RE: Hydrogen Energy California Project  
Application for Certification 08-AFC-8

**Amendment to the  
Revised  
Application for Certification  
(08-AFC-8)  
for  
HYDROGEN ENERGY CALIFORNIA  
Kern County, California**

September 2009

REVISED FIGURE 2-18

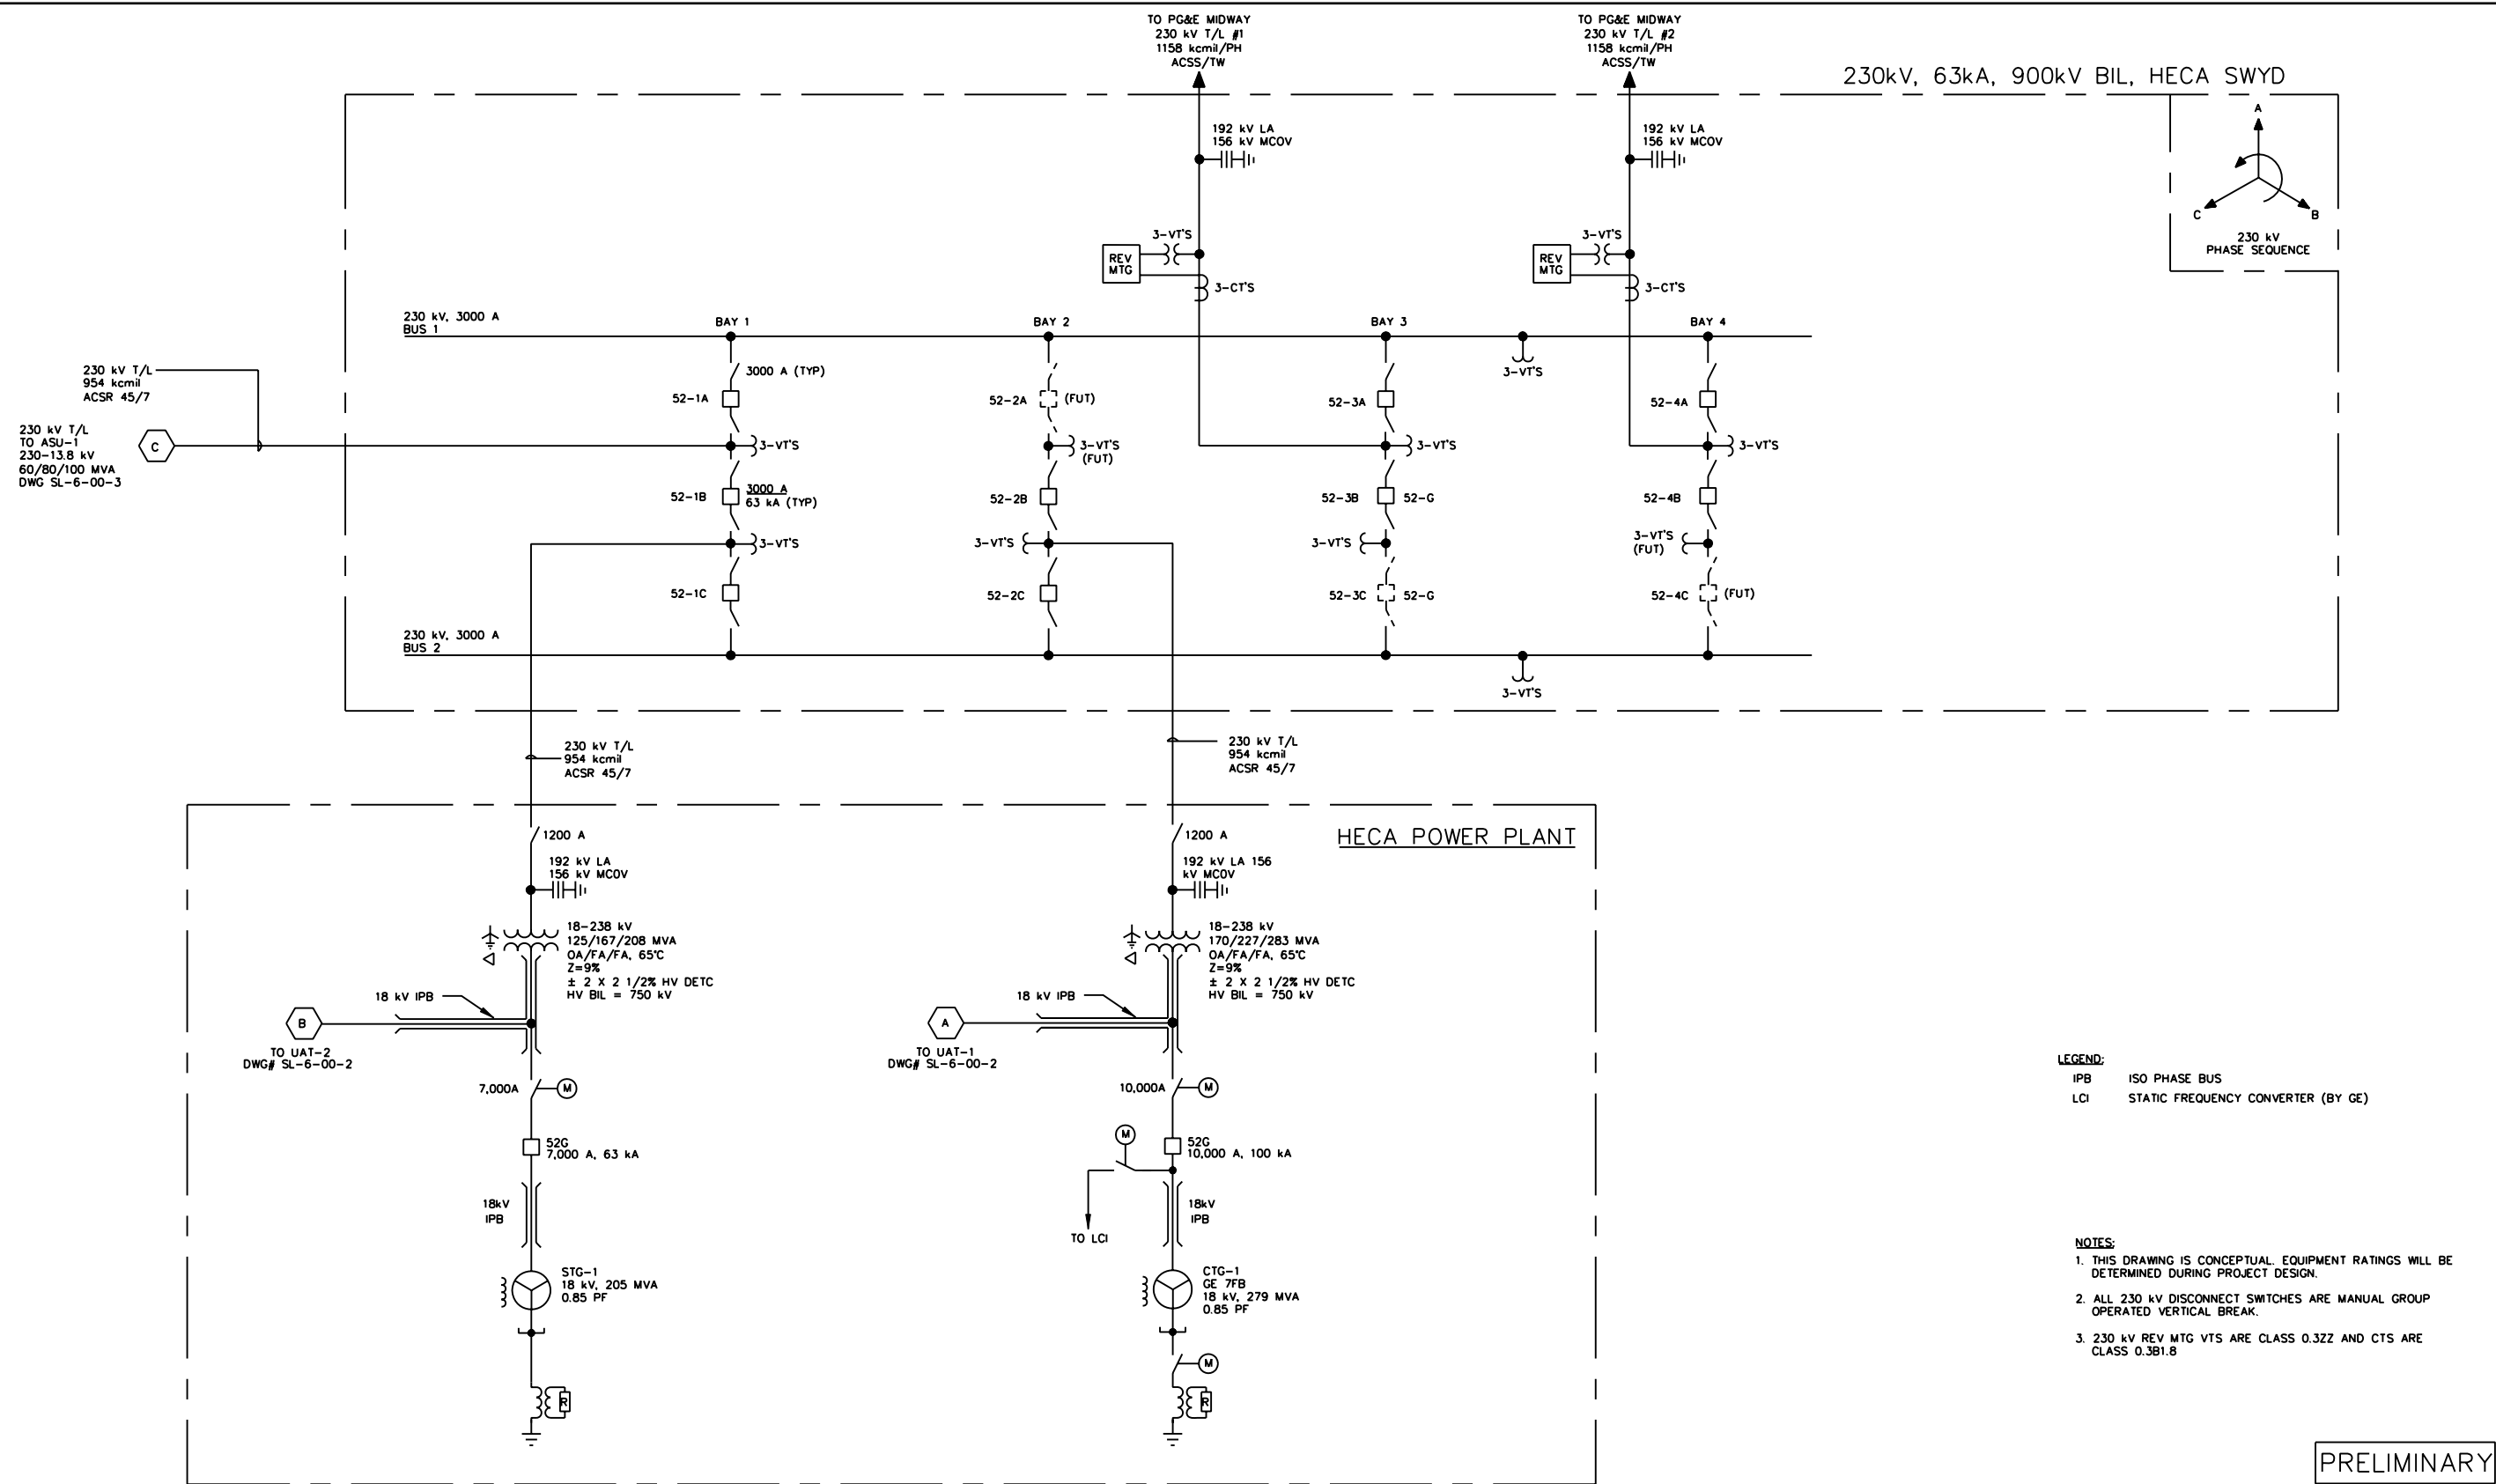
Source:  
 Fluor; Hydrogen Energy California, Kern County Power Project;  
 Flow Diagram, Power Block Systems;  
 Drawing No: A3RW-PFD-25-010, Rev. 2 (09/03/09), Removed Auxiliary CTG

**ELECTRICAL  
 OVERALL ONE-LINE DIAGRAM (1)**  
 September 2009 Hydrogen Energy California (HECA)  
 28067571 Kern County, California  
**URS**  
**REVISED FIGURE 2-19**

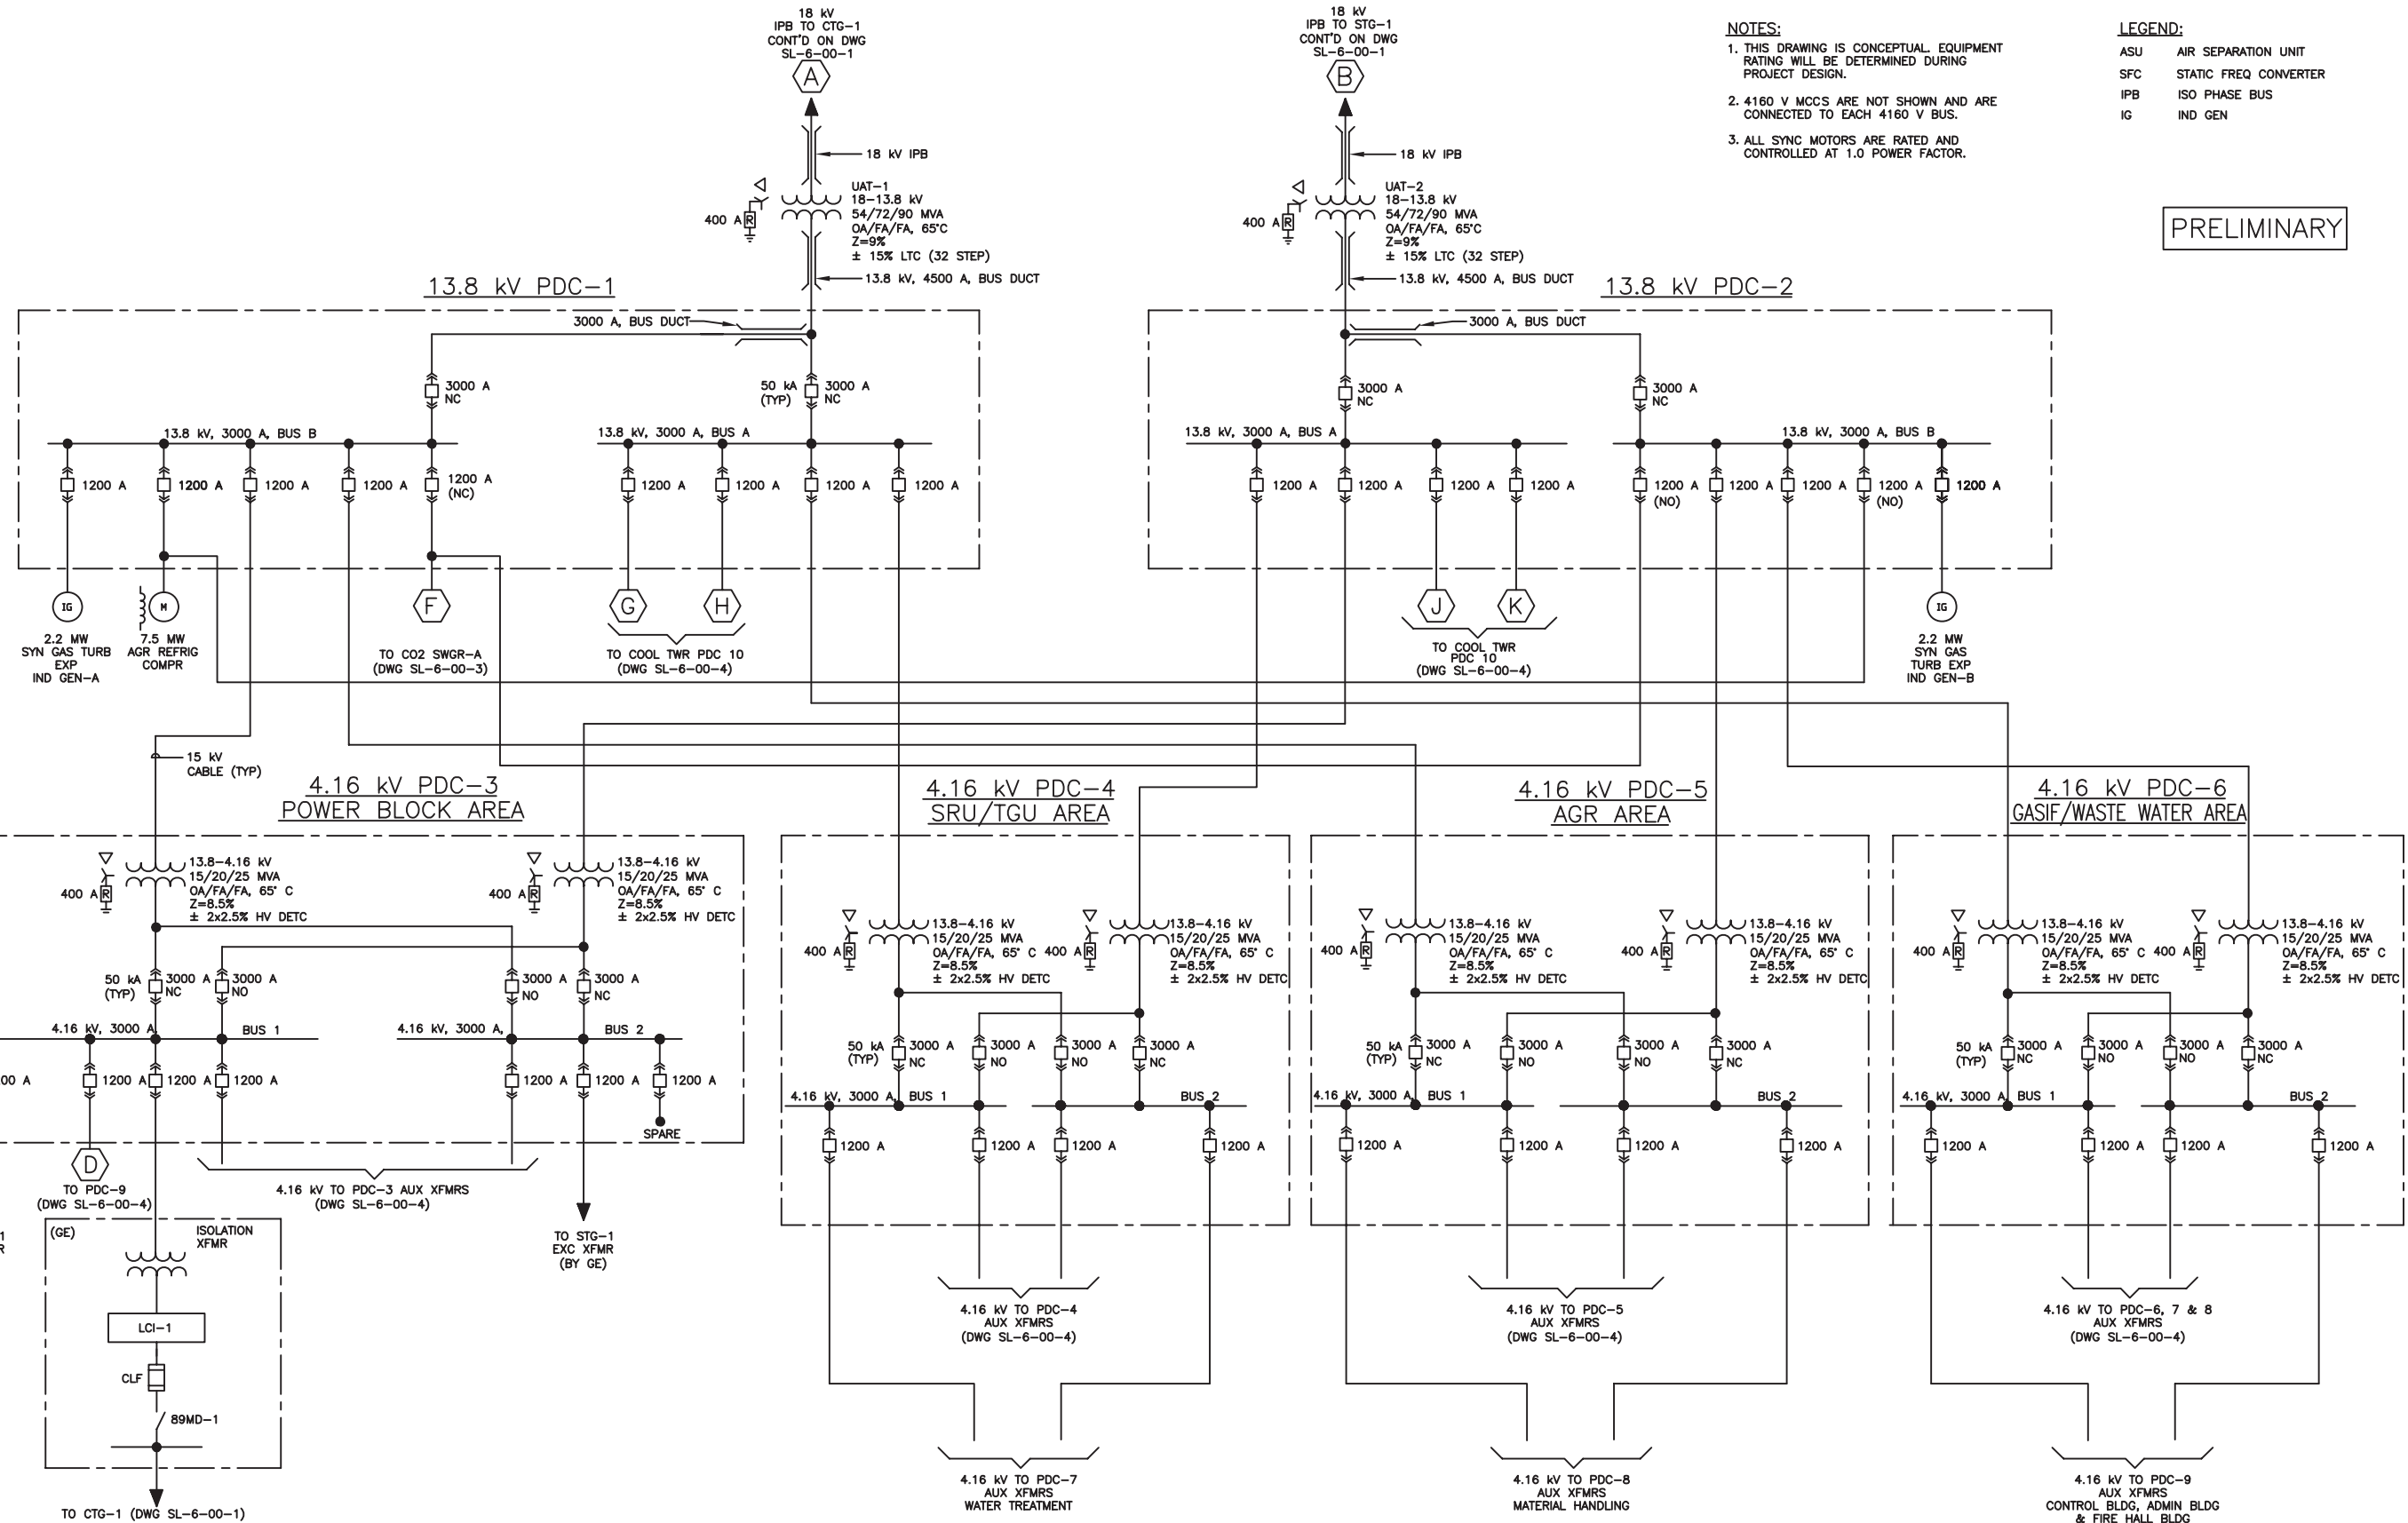
Source:  
 Fluor; Hydrogen Energy California, Kern County Power Project;  
 Electrical Overall One Line Diagram;  
 Drawing No: A3RW00-0-SL-6-001, Rev. 3 (09/09/09), Removed Auxiliary CTG

**REVISED FIGURE 2-23**

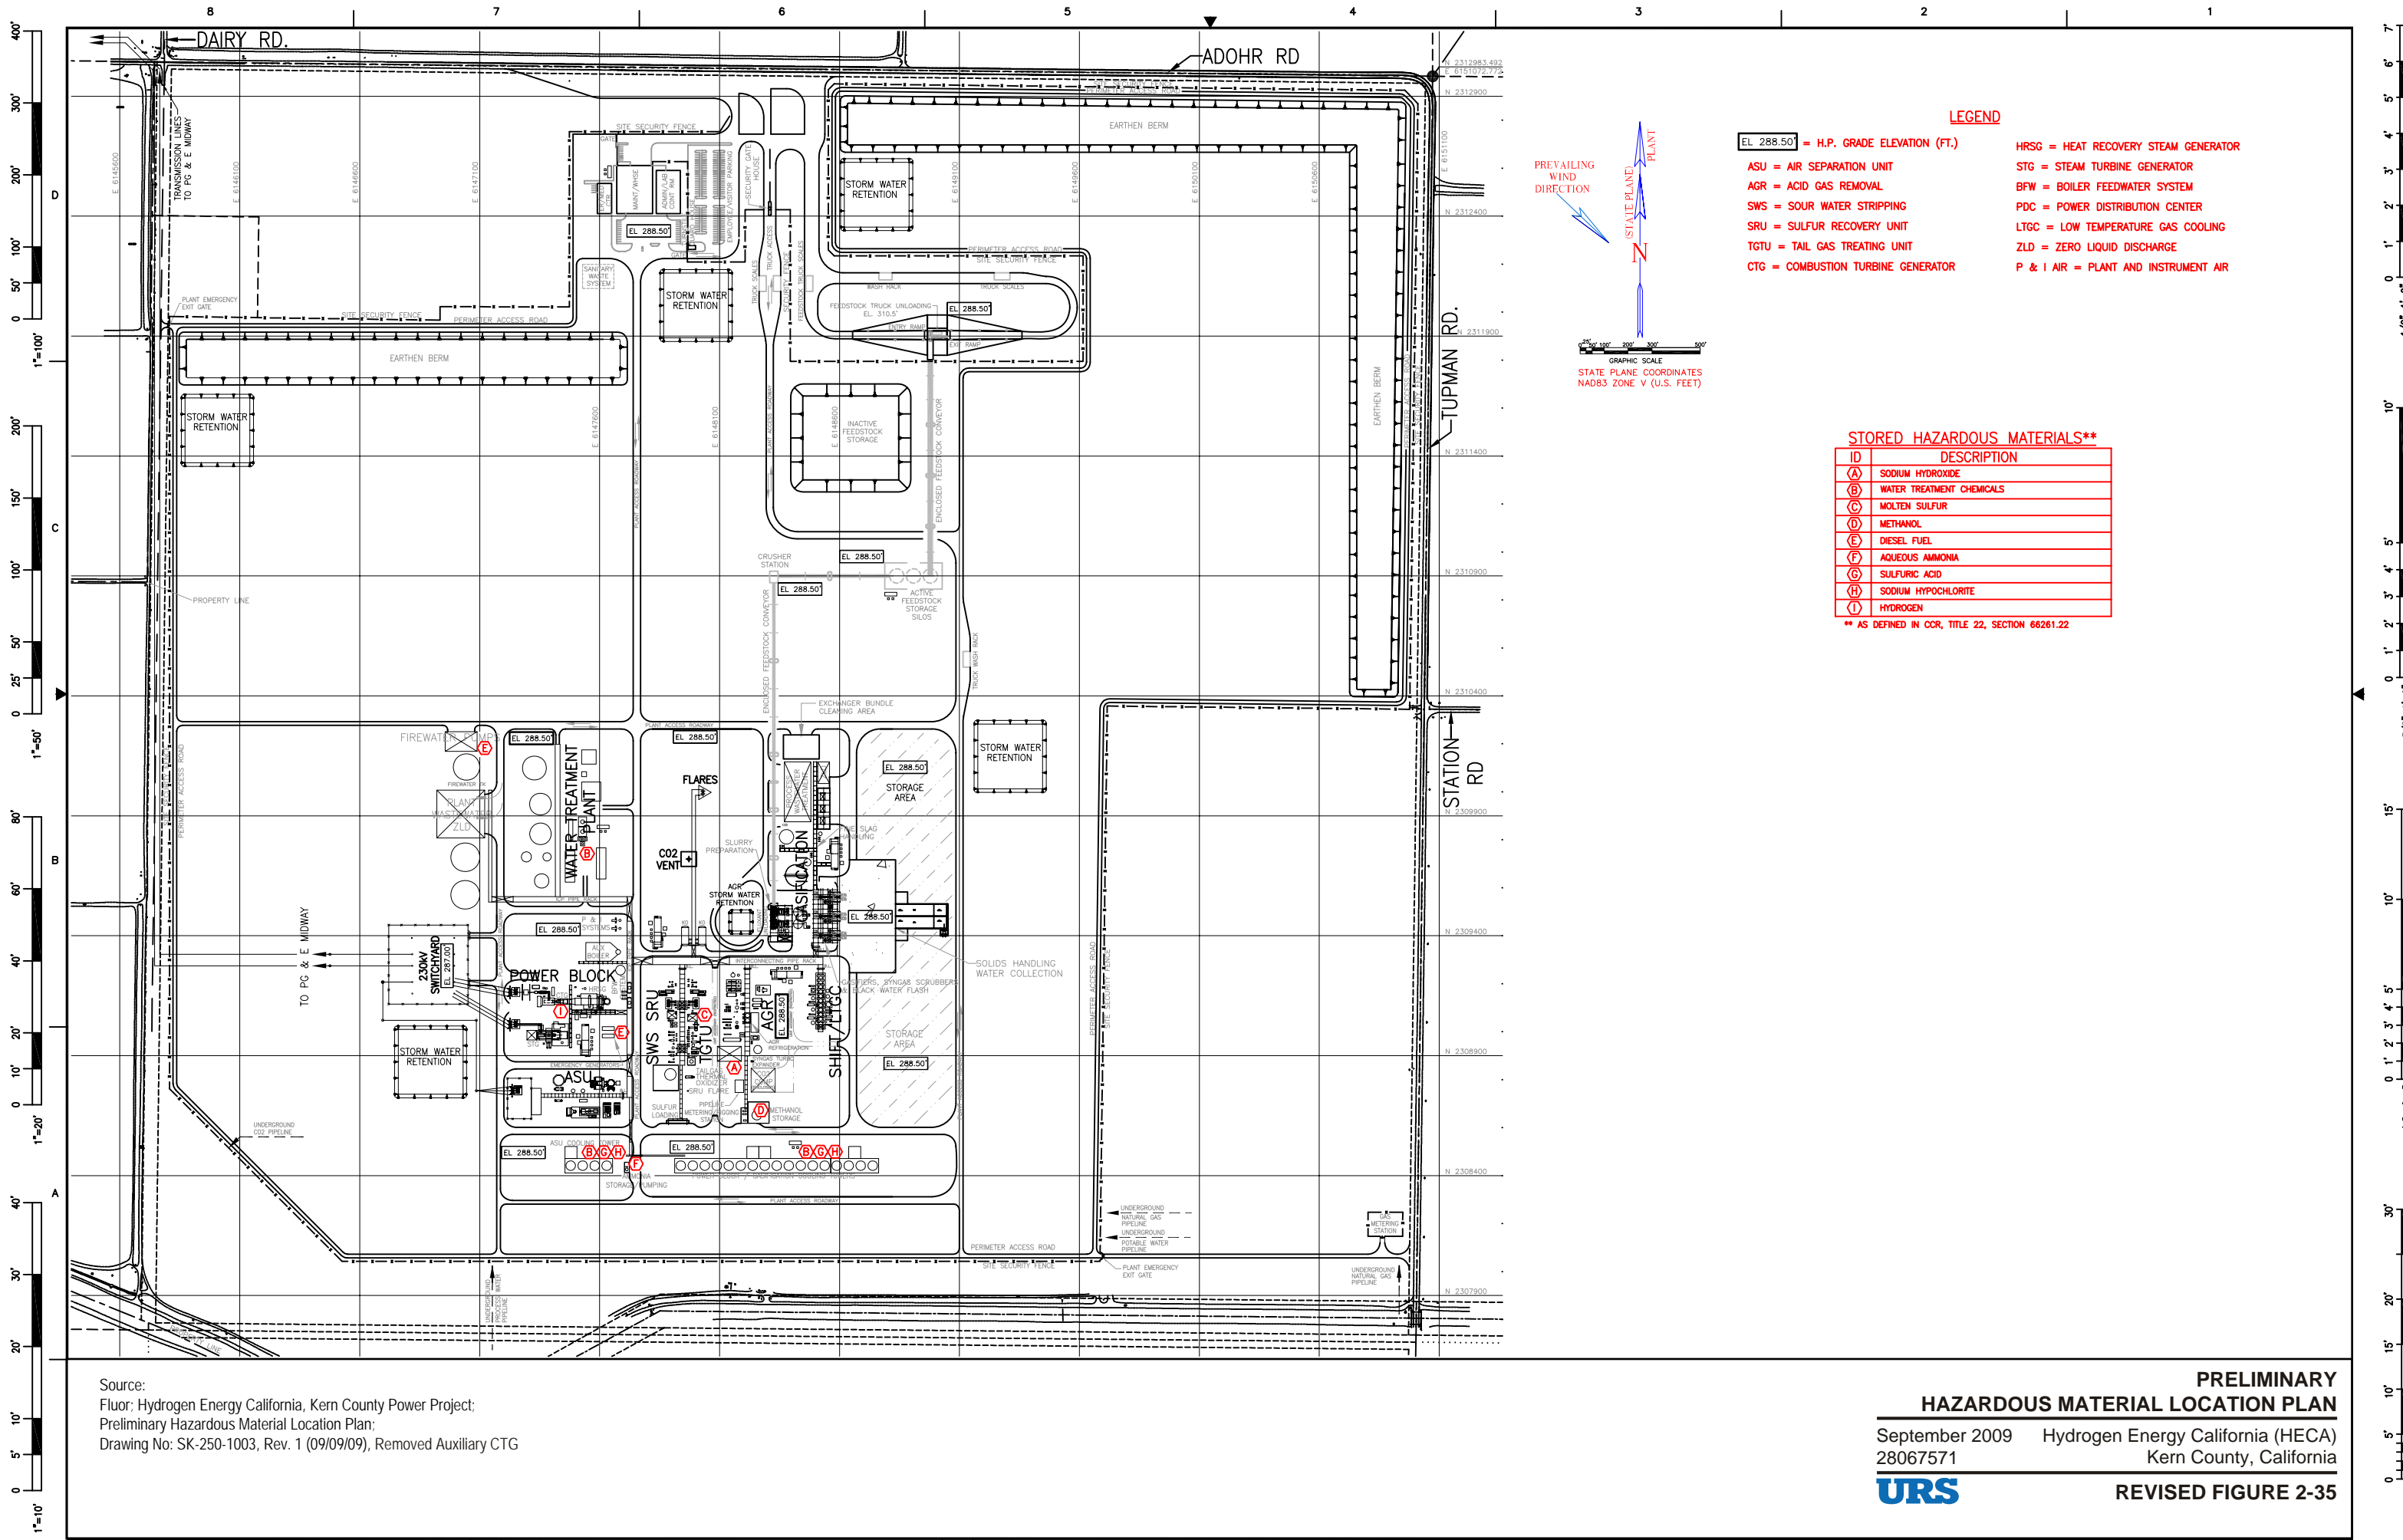
Source:  
 Fluor; Hydrogen Energy California, Kern County Power Project;  
 Flow Diagram, Natural Gas System;  
 Drawing No: A3RW-PFD-25-019, Rev. 3 (09/03/09), Removed Auxiliary CTG
